ADDENDUM 2

- A. Project: Spaulding Building Renovation
- B. Owner: State of North Carolina – Fayetteville State University – Fayetteville, NC
- C. Owner Project Number:
 - 1. SCO ID #: 24-28707-A01
- D. Architect: Studio Archibene, PLLC
 - 1. Architect Project No.: S/A Project Number 2404.00
- E. Date of Addendum: 10 July 2025

11 CLASSROOM - NORTH
 1/4" = 1'-0"
 SHEET A62-01

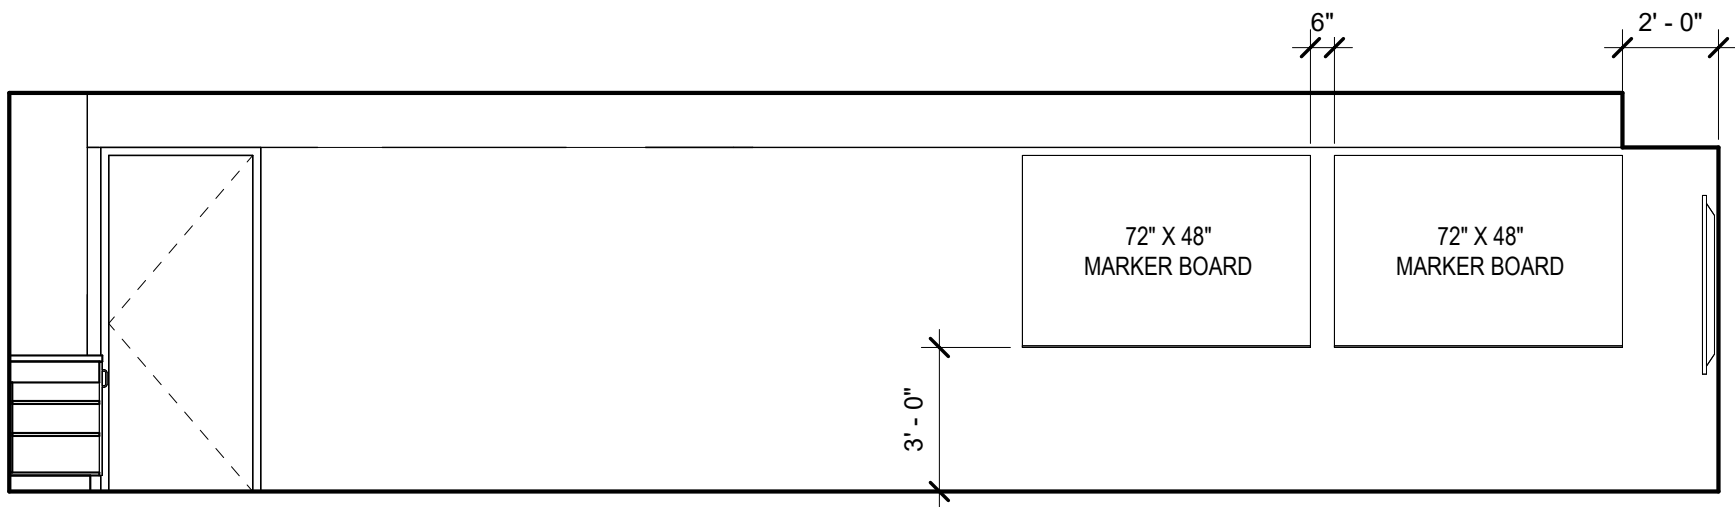
- A. Sheet **A43-03 – Millwork Details** (Sheet not reissued, see attached).
1. ADD Drawing 11 – Classroom – North
(Note size, number, and location of glass marker boards specified in Section 10-11-16
– Glass Markerboards)
